Subject: Response to NRC Request for Additional Information Regarding Relaxation Requests 1 and 2 for Reactor Pressure Vessel Head Penetration Inspection Requirements in Nuclear Regulatory Commission Order EA-03-009 for San Onofre Nuclear Generating Station (SONGS) Units 2 and 3 (TAC Nos. MC1540, MC1541, MC1542, and MC1543)

**SCE Responses to NRC
Request for Additional Information
Summary Information Regarding
Relaxation Requests 1 and 2
(TAC Nos MC1540, MC1541, MC1542, and MC1543)**

**SCE Responses to NRC
Request for Additional Information
Regarding Relaxation Request 1
(TAC Nos MC1540 and MC1541)**

**SCE Responses to NRC
Request for Additional Information
Regarding Relaxation Request 2
(TAC Nos MC1542 and MC1543)**

Best Case UT Coverage:

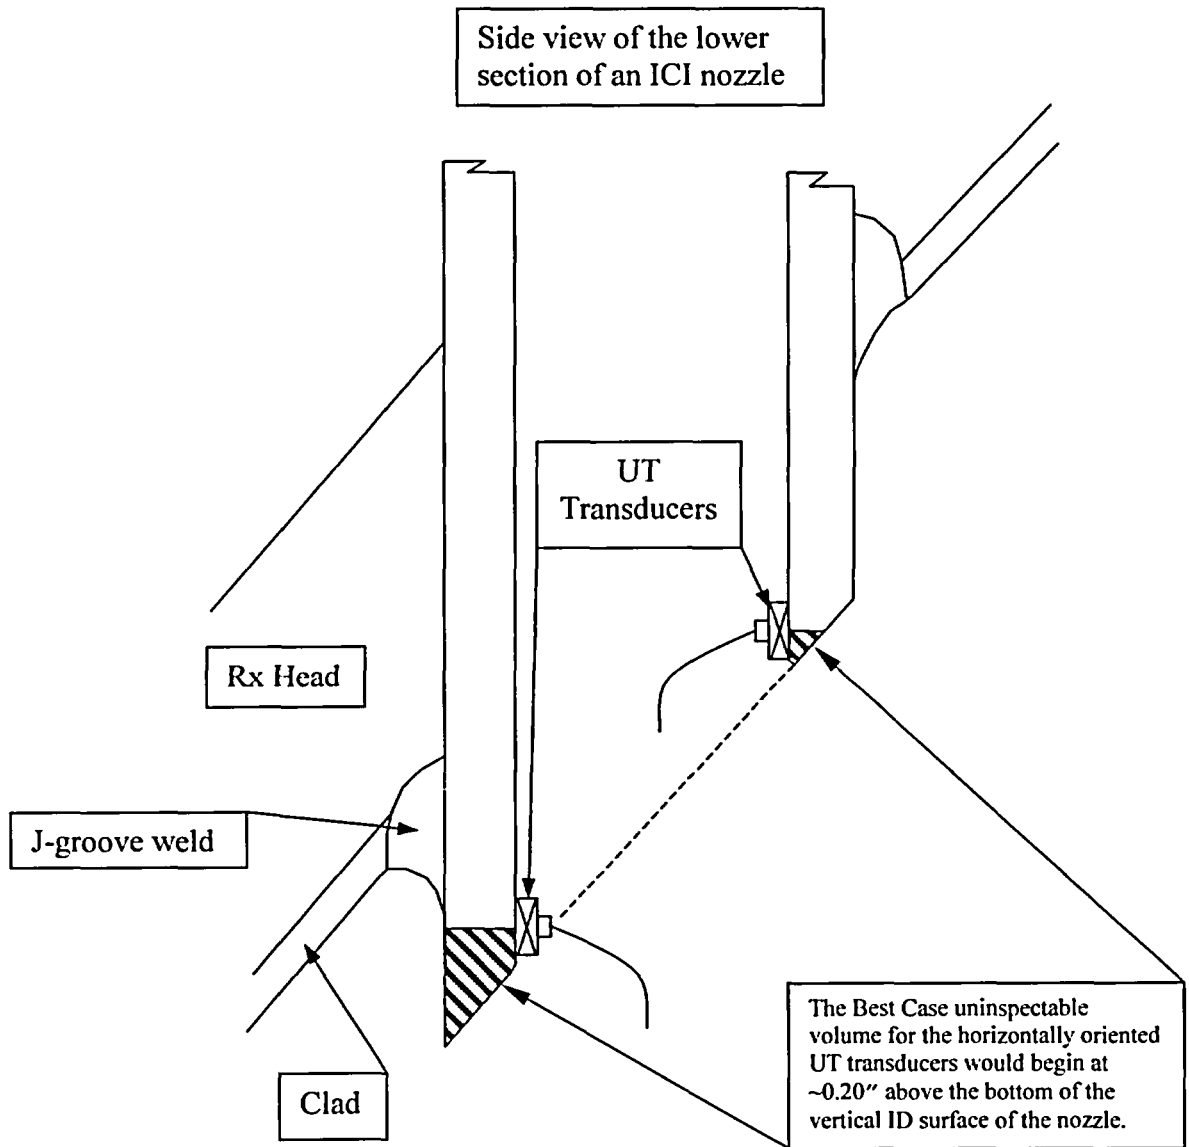
- b) *Provide a sketch to show the UT coverage on the ICI nozzle.*

A design drawing (SO23-901-89) providing detailed dimensions of the ICI nozzle is provided as Attachment 4. The sketches provided below are intended to aid in visualizing the location of the uninspectable volume using UT examinations, and

are not meant to be taken as accurate depictions of the nozzle geometry. The sketches are not to scale.

The best case sketch shows the uninspectable volume at the bottom tip of the ICI nozzles that results from the nozzle shape. The expected case sketch shows the uninspectable volume due to loss of coupling to the nozzle which is likely a result of nozzle distortion which occurred during installation.
